City of Hammond RFP 23-39 City of Hammond Maintenance Shop Addition

PROPOSED MAINTENANCE BUILDING ADDITION FOR-CITY OF HAMMOND

Addendum #1

1. Page S2, Section A - End view - Pit

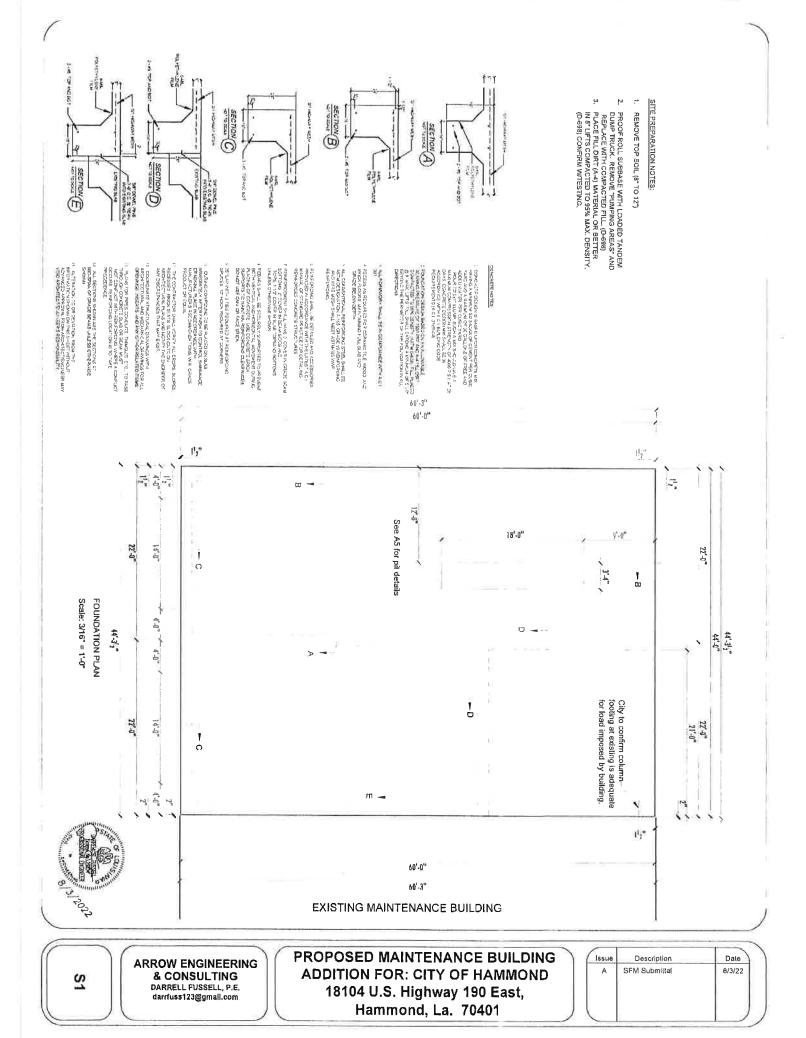
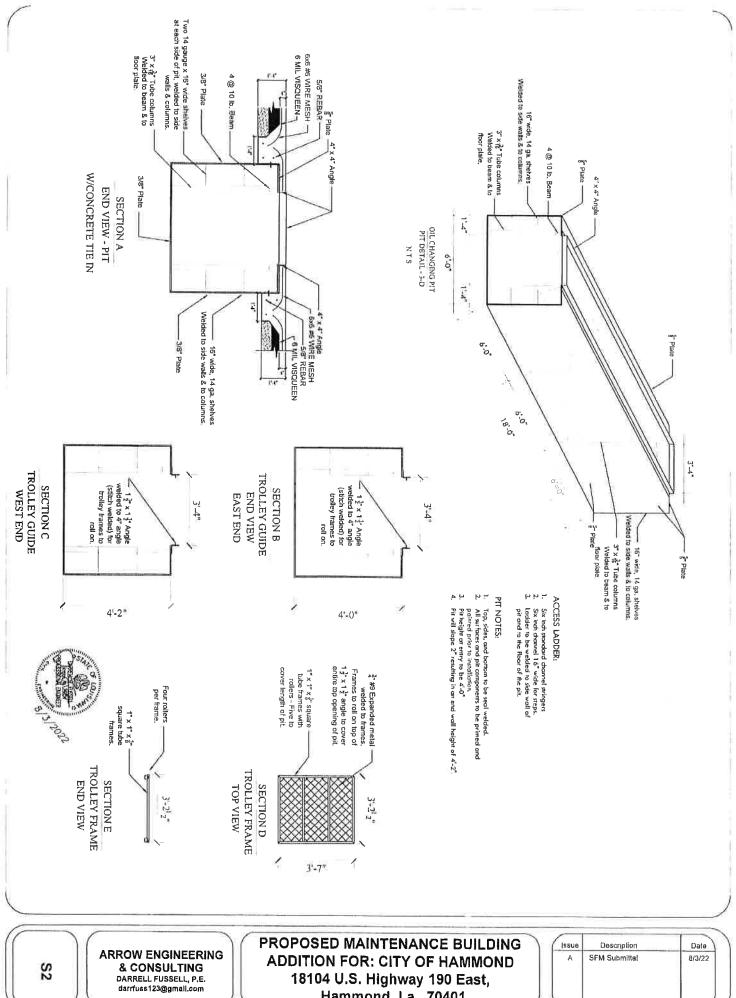
The Pit detail shows a 4 x 4 angle where the concrete ties in to it; that detail indicates a 4" concrete slab.

The slab is to be six inches thick therefore, the 4 x 4 angle should be a 6 x 4 angle.
